Subject: Duke Energy Carolinas, LLC
William States Lee III Nuclear Station - Docket Nos. 52-018 and 52-019
AP1000 Combined License Application for the
William States Lee III Nuclear Station Units 1 and 2
Responses to Request for Additional Information
Ltr# WLG2011.06-03

Lee Nuclear Station Response to Request for Additional Information (RAI)

Reference NRC RAI Number: ER RAI 190 Supplement, Site Layout and Plant Description

Reference NRC RAI Number: ER RAI 210 Supplement, Ecology - Aquatic

River Water Intake Structure
Sheet 6 of 7
Figure 5.3-1, Rev 3

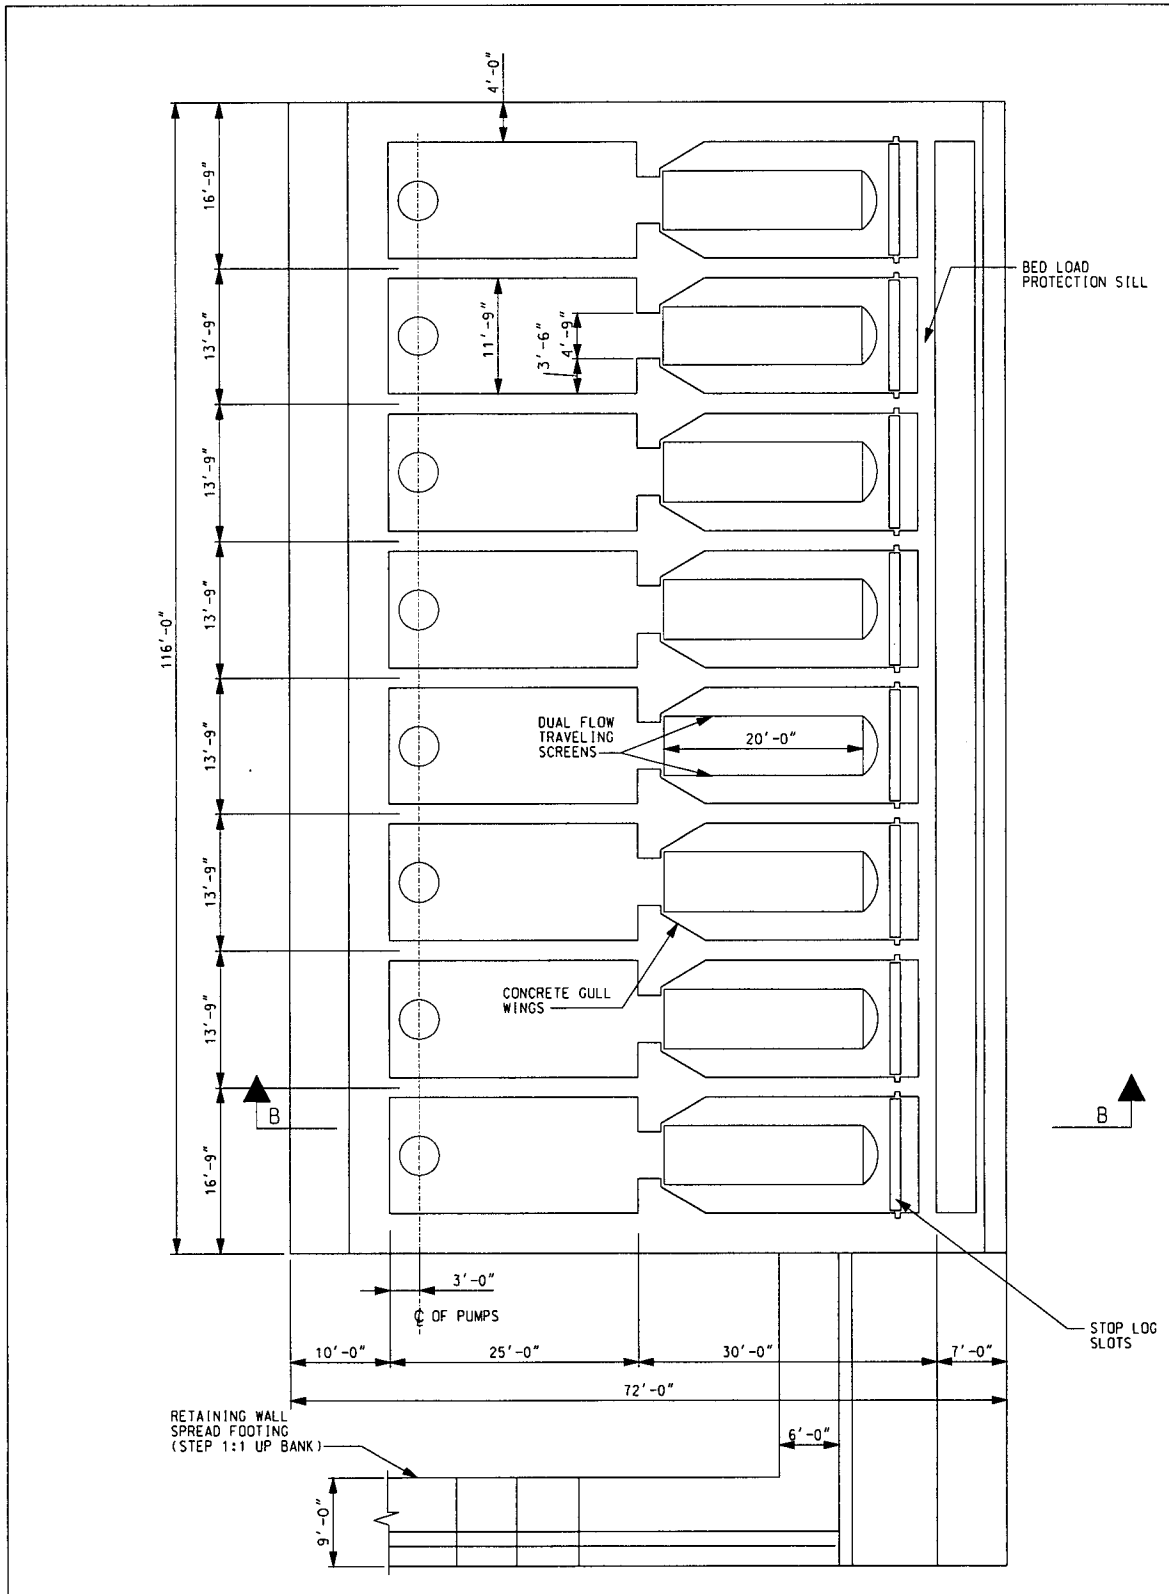
Provide physical descriptions (e.g., location, dimensions, construction materials, pump systems) of the "River Water Intake Subsystem" and the "Refill Subsystem Intake" referred to in Supplemental ER Figure 3.3-1, Sheets 1 and 2.

Discuss any changes to the site preparation and construction methods, affected area, spoils volume and disposition, timing, and duration for the river intake and associated distribution systems. Provide a narrative description of the relationship or interconnections between these intake(s) and the various Make-Up ponds, including the expected flow rate and duration of refill pumping operations.

During a conference call on May 18, 2011 the NRC requested that figures be provided in RAI 190 be enlarged.

In addition to providing enlarged figures, the width of the Dual Flow Traveling Screens (refer to Mat Plan View @ El 497'-0" on updated ER Supplement Figure 5.3-1 Sheet 6 of 7 [Attachment 190S-01]) has been increased from 12'-4" to 20'-0" to provide additional design margin and to ensure through-screen velocity of the intake screens will be less than 0.5 feet per second. This change also results in the overall width of the River Water Intake Structure increasing by 8'-0".

Make-Up Pond A Intake Structure
Sheet 3 of 5
Figure 5.3-3, Rev 3

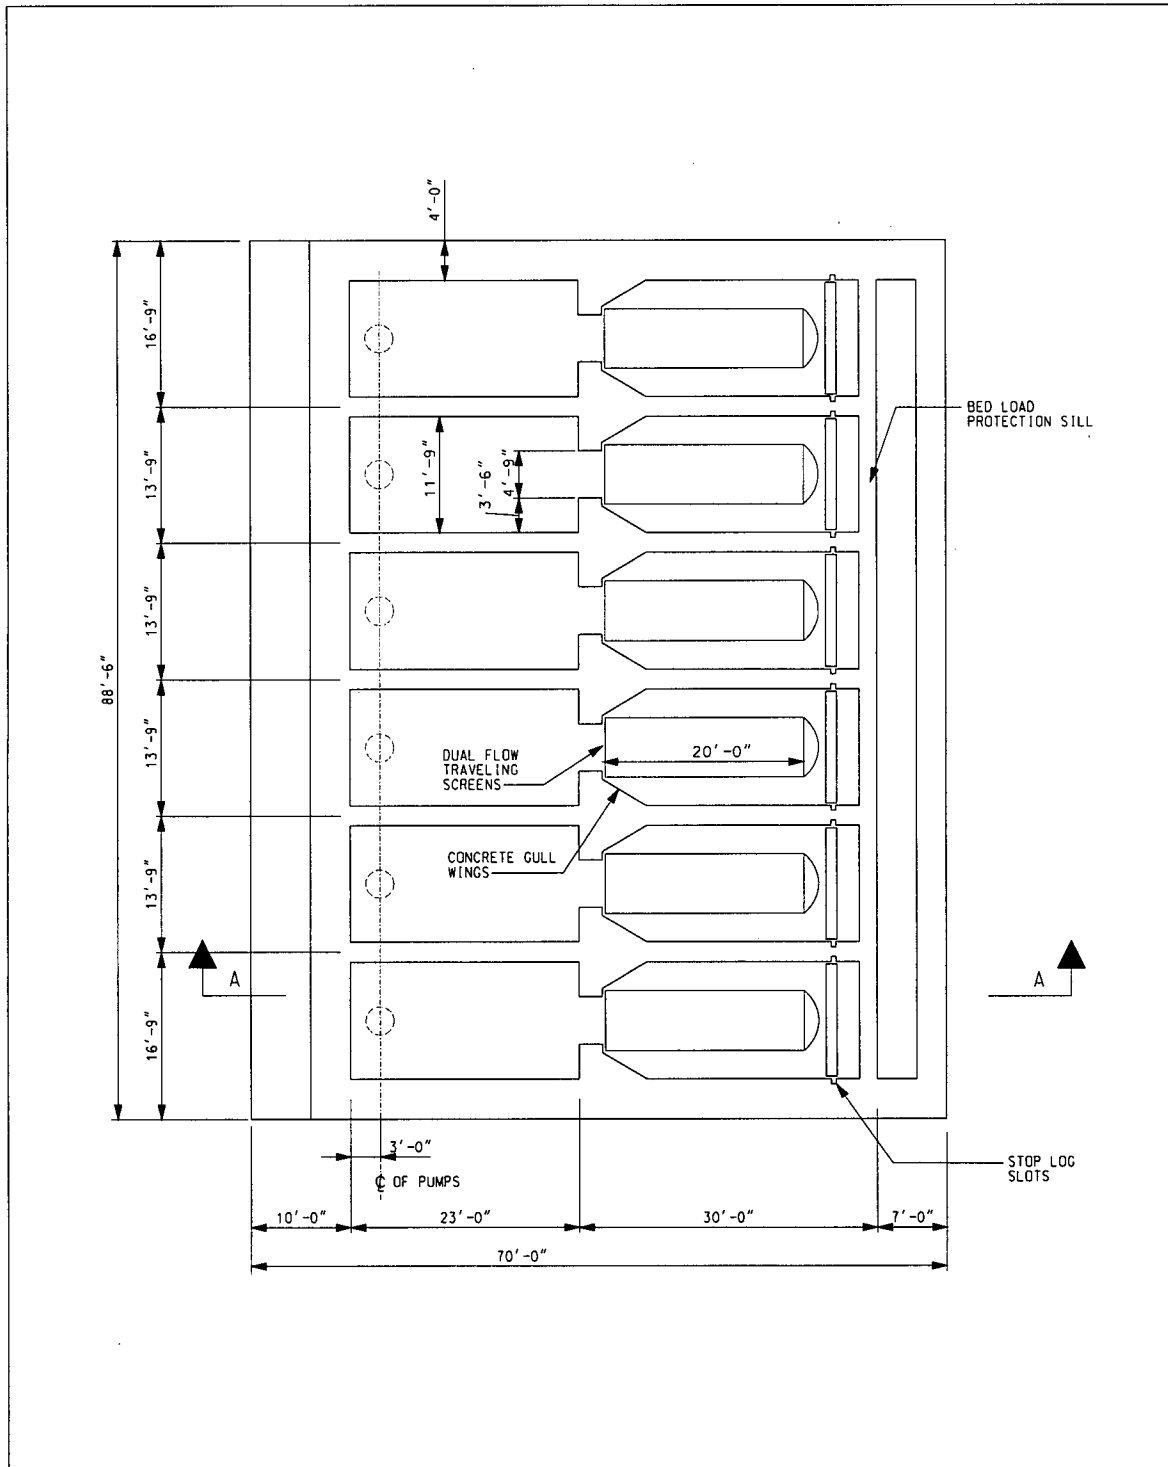
Provide bathymetric maps of Ponds A, B, and C that show clearly labeled contour lines with the locations of the intake screen and supporting structures superimposed. Provide plan and section views of each intake structure. For clarity and legibility, print the maps in black and white. Describe what is known about the options for wedge wire slot sizes for the traveling screens, particularly if an estimate or range of potential slot sizes is known. Provide information about the height the Pond B and C drum screens will be elevated above the substrate. Also, describe the potential cleaning methods for the Ponds A, B, and C intake screens. Indicate in the response when and how through-screen velocity calculations will be provided to the NRC (e.g., through submittal of a copy of the National Pollution Discharge Elimination System permit application).

During a conference call on May 18, 2011 the NRC requested that figures be provided in RAI 210 for Pond A be enlarged.

In addition to providing enlarged figures, the width of the Dual Flow Traveling Screens (refer to Mat Plan View @ El 510'-0" on updated ER Figure 5.3-3 Sheet 3 of 5 [Attachment 210S-01]) has been increased from 12'-4" to 20'-0" to provide additional design margin and to ensure through-screen velocity of the intake screens will be less than 0.5 feet per second. This change also results in the overall width of the Make-Up Pond A Intake Structure increasing by 8'-0".
